Sheet No.: S2.02

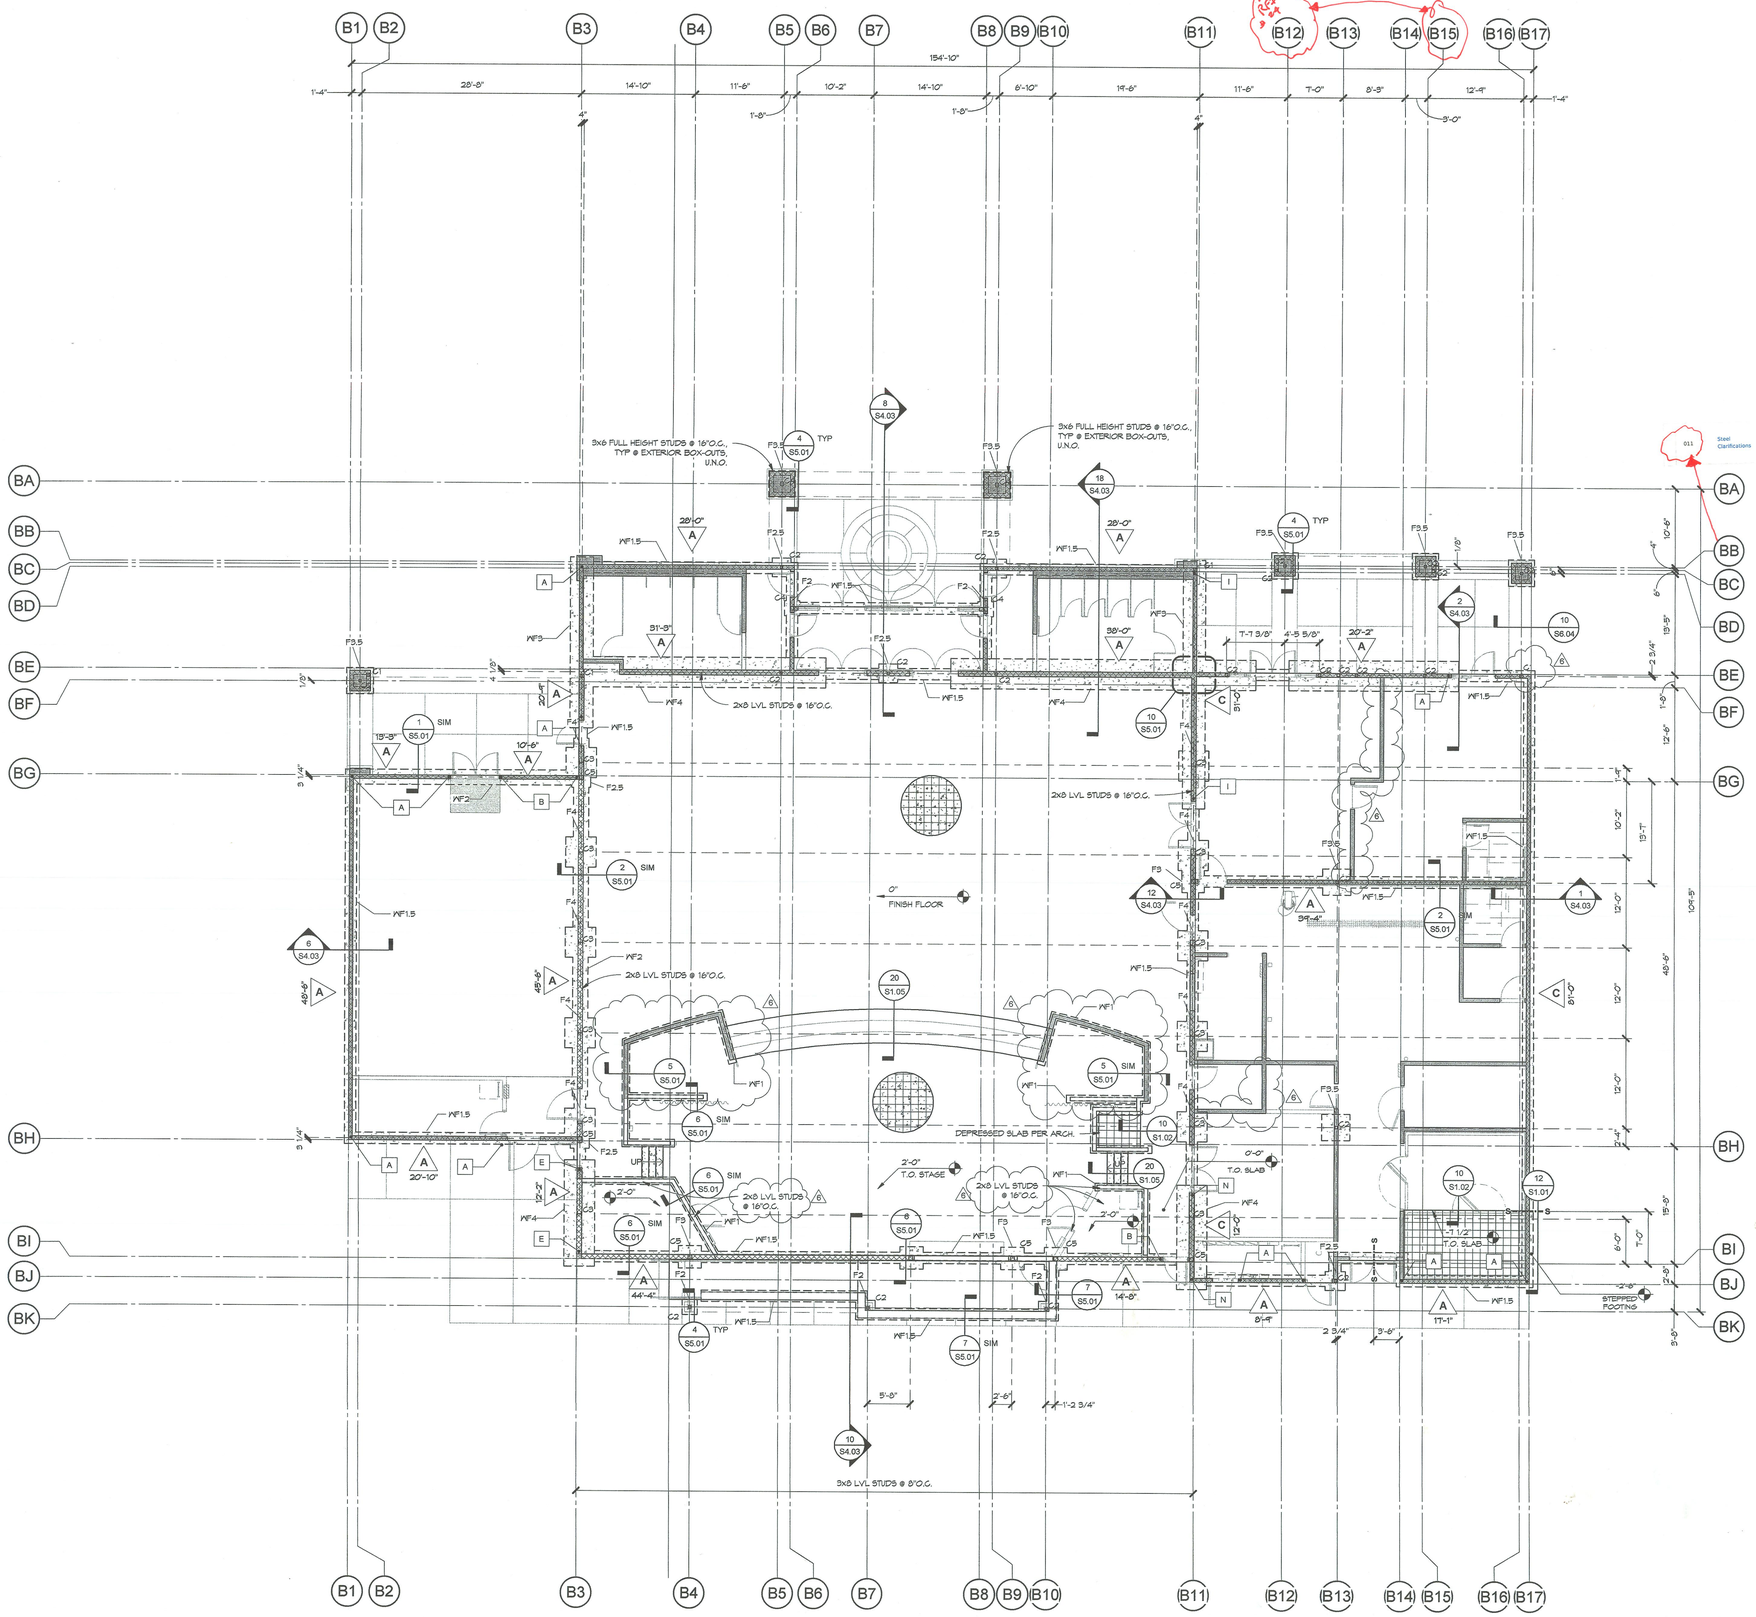
Contractor: Kern Steel (2)Please reference attached.1. Please reference page 1 of attached sketch. We have considered 1/8" offset dimension shown in structural plan S2.02 as typo error and fixed the columns to GL BB. Please confirm this is correct or if columns need to in fact be offset 1/8"-2. Please reference page 2 of attached sketch. Since design drawings do not have sufficient information regarding clouded columns height, we have fixed top of column at top of parapet elevation (Since columns are shown on high roof plan). Please confirm this is correct. If not please provide required changes.

20 BUILDING A - ROOF FRAMING PLAN — AD6-S3 — S3.01 — 1/8" = 1'-0"

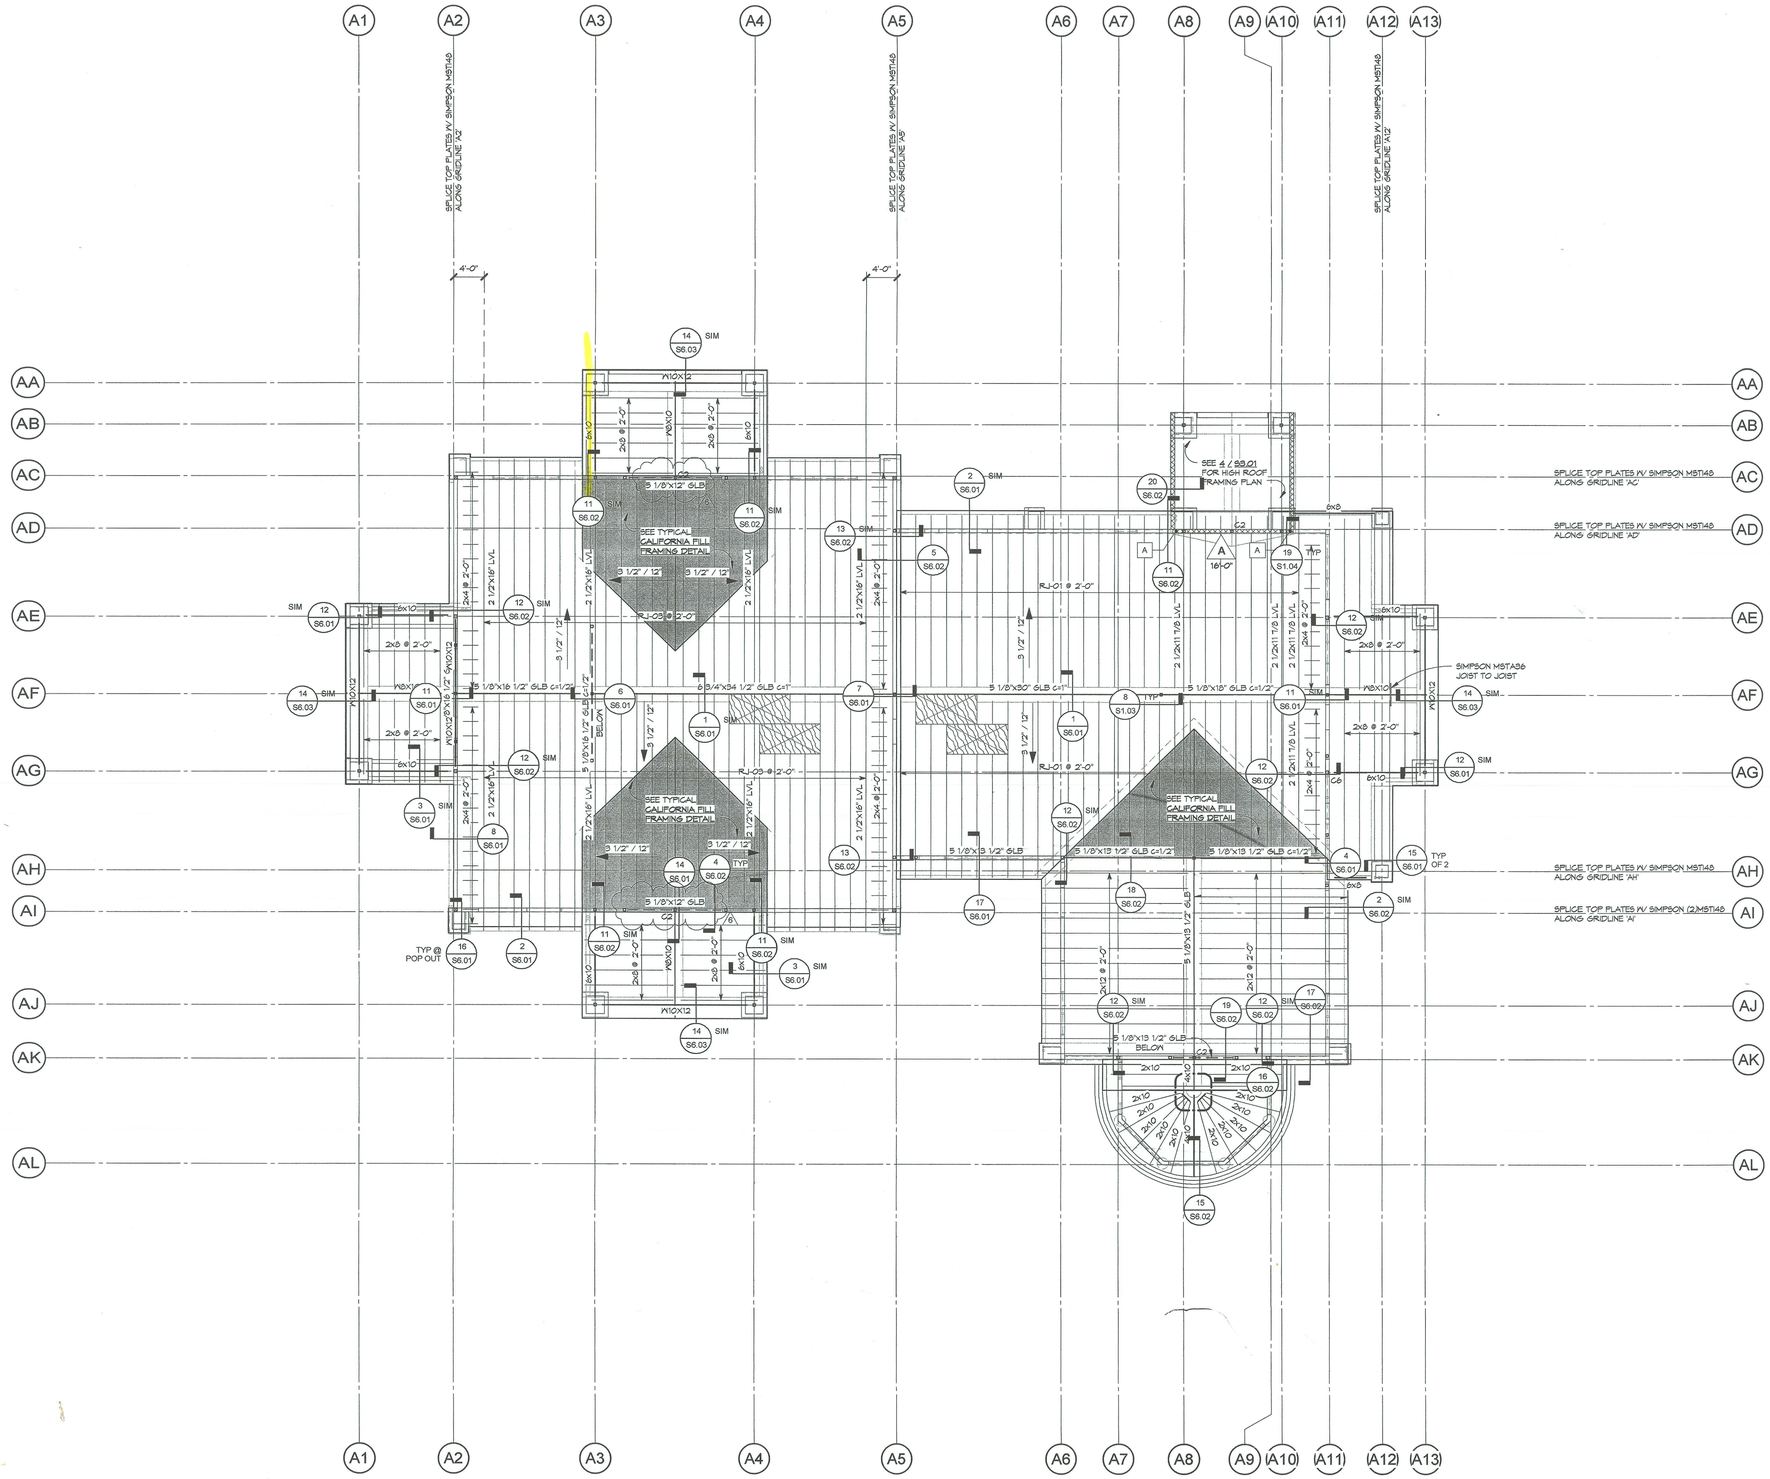
Contractor: Lundgren Reference: S3.01 (4),A3.11 (2) Tower at (AD) & (AB),A6.10, E2.10 Question: A3.11(2) Colum line (AD) & (AB), shows a stucco to the bottom of the rafters. A6.10 at that same location shows a 10' ceiling height. Additionally: there is no access door shown in the 10' ceiling shows no access door to the light above the ceiling to below rafter location (E2.10). Can I get clarification?

20 BUILDING B - LOW ROOF FRAMING PLAN
S4.03 | S3.02 | 1/8" = 1'-0"

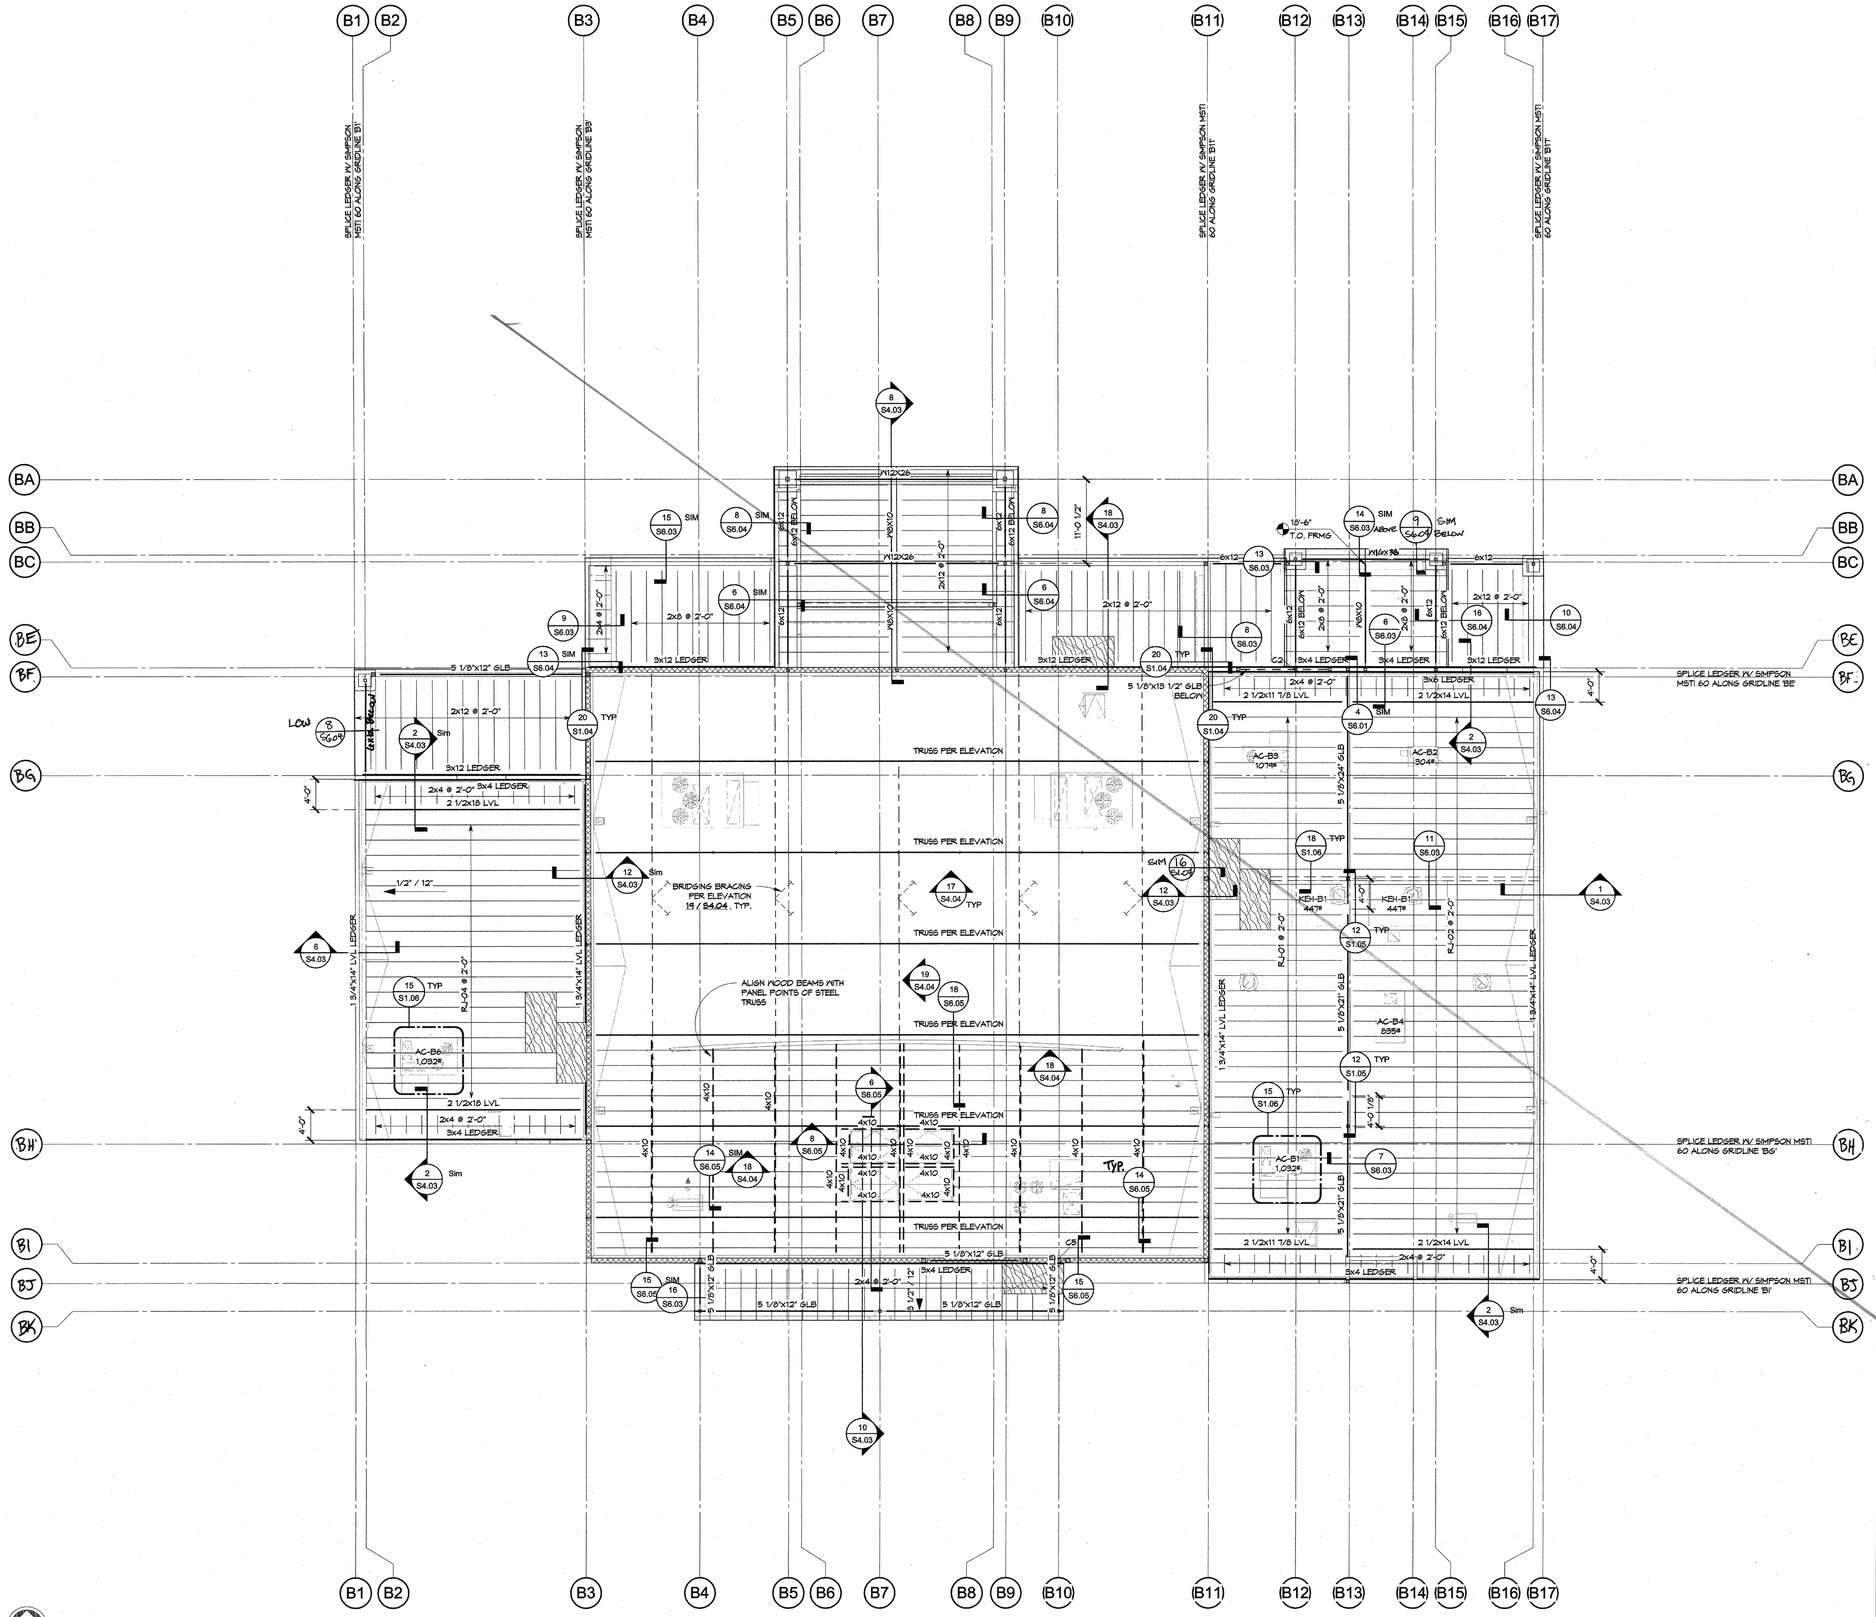
The clouded column elevation is okay.

17 TYPICAL TRUSS ELEVATION

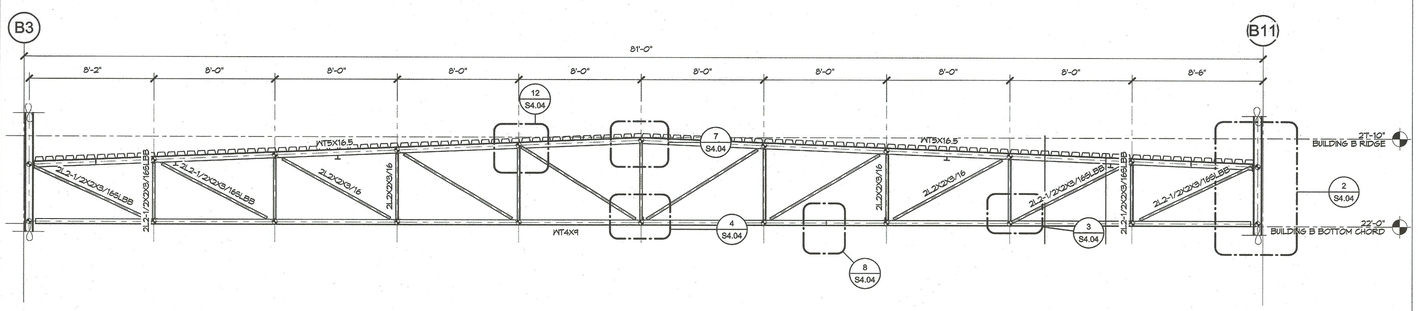
Contractor: Kern Steel (1)Question:Please review attached.We are providing truss type per elevation 17/S4.04 at locations highlighted in pink and 18/S4.04 at locations highlighted in blue. Please confirm this is correct.

Sheet No.: S6.01

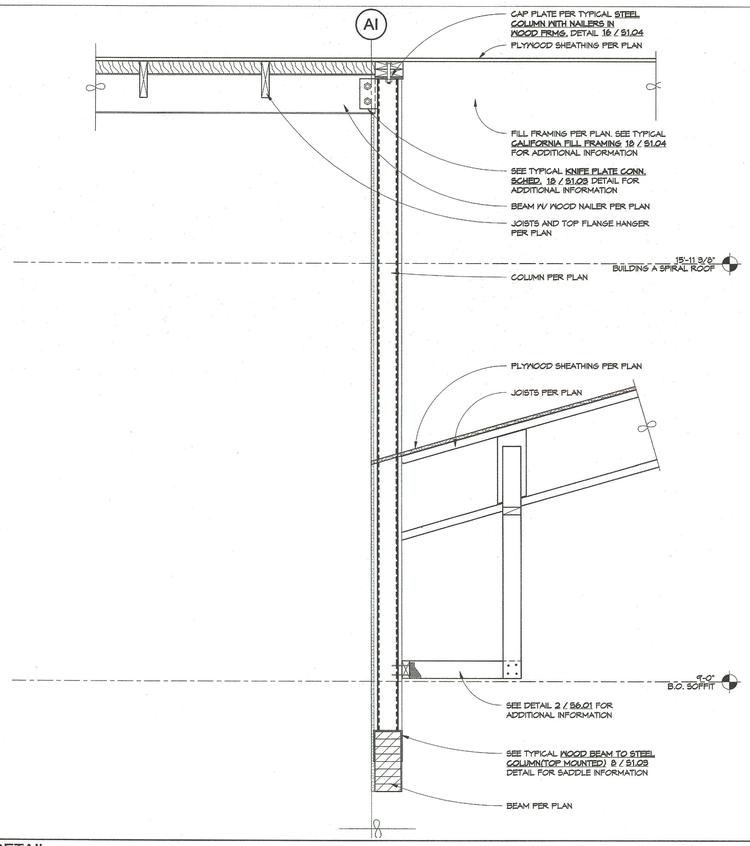
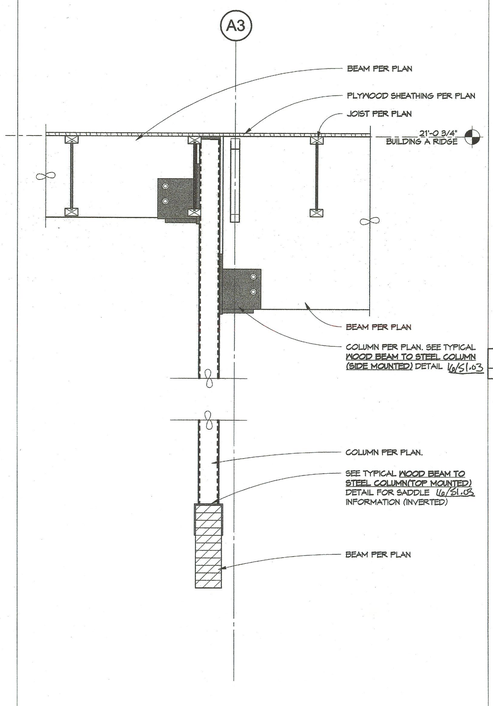
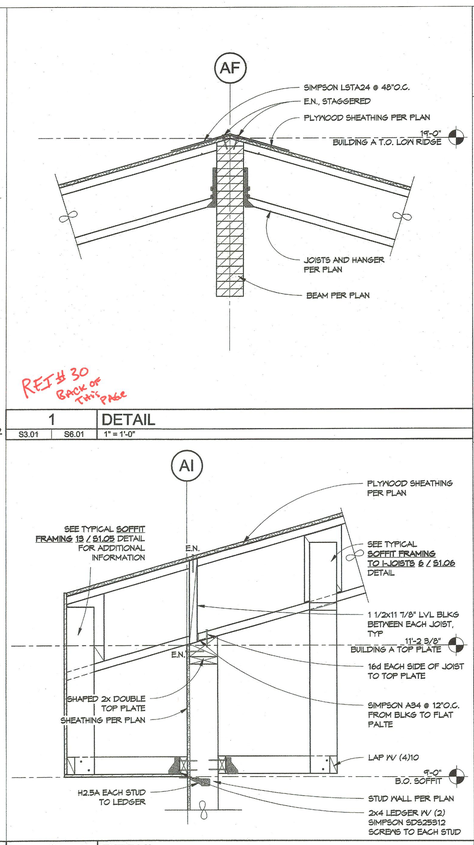
0030	Top Plate Elevation	Kern Steel (11) Please reference 1 thru 3. By following the bottom of sheathing elevation per structural section 1,11/S6.01 and 3-1/2" per foot slope, we arrive top plate elevationas shown in page 2 which is below ridge beam along GL AC and AL and AD and AH. If top plate elevation needs to be fixed at 11'-2 1/2" per approvercomments please advise which one of below options needs to be followed.1. bottom of sheathing per 1,11/S6.01.Or please advise if we shall fix top plate by following the bottom of sheathing elevation and roof slope per design drawing as submitted for approval.	Disregard approvers clouded elevations. Original elevations provided by KSF are correct. Approver took elevations to incorrect plate.	Closed
